ADDENDUM NO. 3

PROJECT NAME: East Campus Recreation Center Renovation and Addition
UNL PROJECT NUMBER: A016P039
BID INVITATION NUMBER: 2237-13-7200

DATE OF ISSUANCE: Monday, September 30, 2013

16
 S310

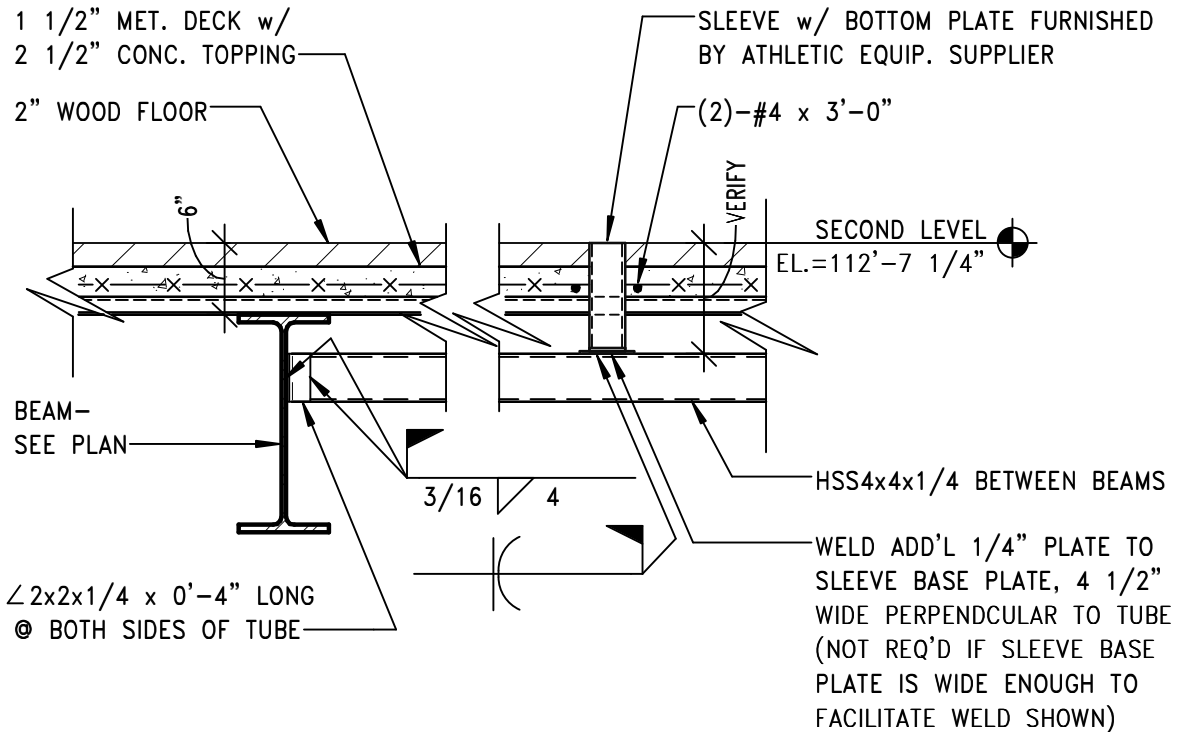
- ADD 3-32.** Refer to Sheet S310, Framing Details; Add Detail 16/S310 as shown on **Attachment S310-H.**
- ADD 3-33.** Refer to Sheet S503, Framing Details – Existing Building; Add Detail 6/S503 as shown on **Attachment S503-B.**
